Subject: Comments re. Draft EIS for Olowalu Master Plan

Town Master Plan at Olowalu, Hawaii

# Olowalu Wharf Shoreline Erosion Rates Map Proposed Olowalu Town Master Plan

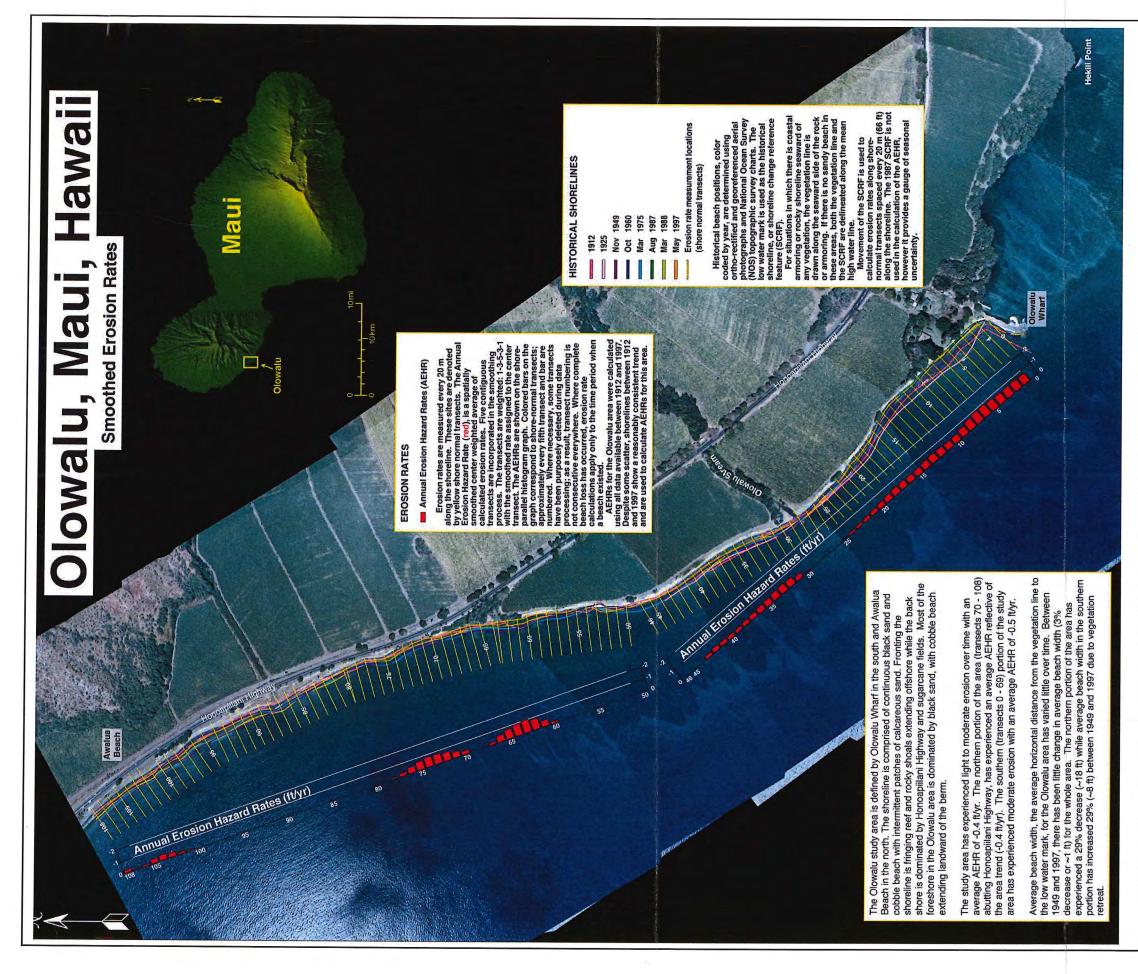
Page 58 – The EIS says that potential impacts from shoreline erosion and future sea level rise have not been identified. This is a very serious omission and the Final EIS should include analysis of both shoreline erosion and sea level rise.

Since the preparation of the Draft EIS, the County of Maui has adopted erosion rate maps for Olowalu. According to the Erosion Maps prepared for the County of Maui Department of Planning, the Olowalu study area is defined by Olowalu Wharf and Hekili Point. Olowalu Wharf erosion map encompasses the shoreline segment from Olowalu Wharf to the south to Awalua Beach to the north while the Hekili Point erosion map encompasses the shoreline segment from Olowalu Wharf to the north to Ukumehame Gulch to the southwest. The shoreline on the Olowalu Wharf erosion map is comprised of continuous black sand beach and cobble beach with intermittent patches of calcerous sand, while the Hekili Point erosion map is comprised of both sand and cobble beaches. Fronting the shoreline is a fringing reef and rocky shoals extending offshore while the back shore is dominated by Honoapi'ilani Highway and former sugarcane fields and kiawe trees. See Figure 16 and Figure 17.

The Olowalu Wharf erosion map study area experiences light to moderate erosion over time with an average Annual Erosion Hazard Rate (AEHR) of -0.4 ft/year. The northern portion of the area (transacts 70-108) abutting Honoapi`ilani Highway has an average AEHR reflective of the trend of -0.4 ft/yr. The southern area (transacts 0-69) has experienced moderate erosion with an average of -0.5 ft/yr. Refer to **Figure 16**.
